DATE: November 10, 2023
PAGE: 1 of 17 (INCLUDING THIS PAGE)
TO: ALL CONTRACTORS
FROM: DENISE KING
PROJECT: ROBERTSDALE WASTEWATER TREATMENT PLAN UPGRADES
USDA RURAL DEVELOPMENT
FOR CITY OF ROBERTSDALE
GMC PROJECT NO. CMOB210098(A)
RE: ADDENDUM #4

ADDENDUM NUMBER 4

WASTEWATER TREATMENT PLANT UPGRADES

GMC PROJECT NO. CMOB210098A

SIDEWALK DETAIL
N.T.S.

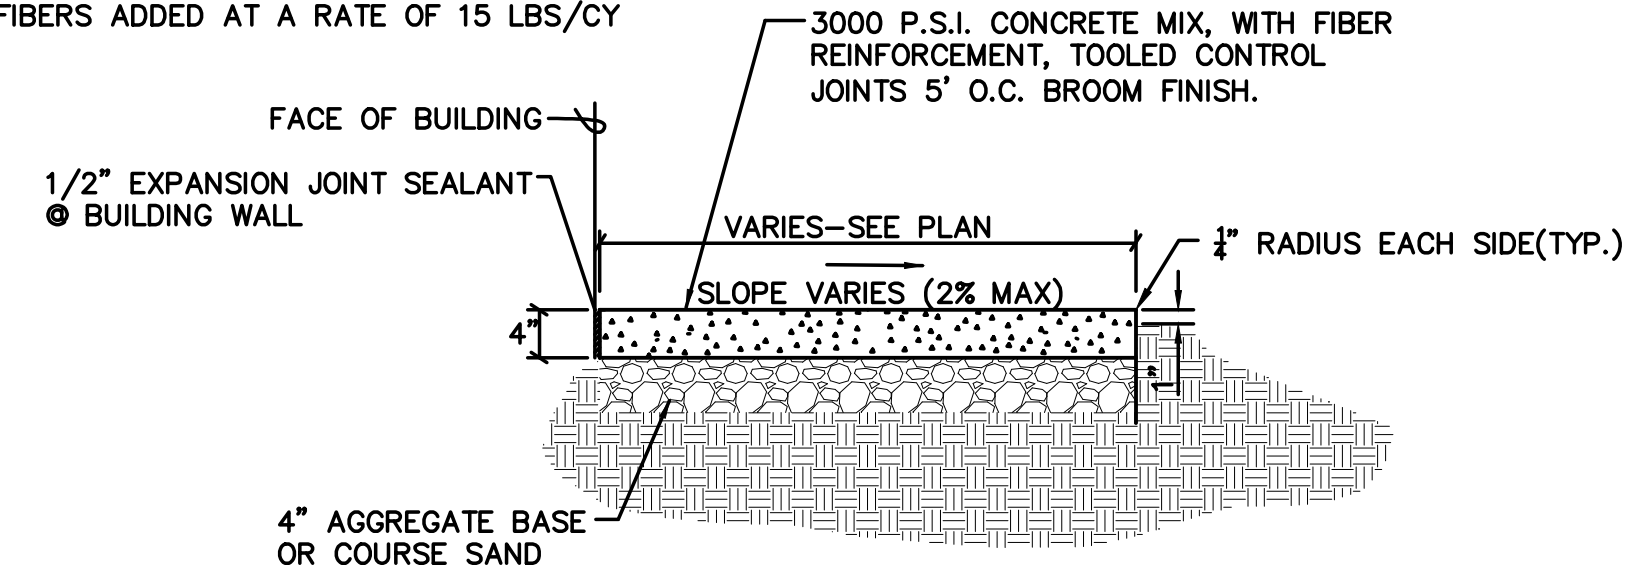
- 4.16 **Please provide a sidewalk detail?**

Answer: Sheet C-902 has been revised to include a sidewalk detail and is included as an attachment to this addendum.
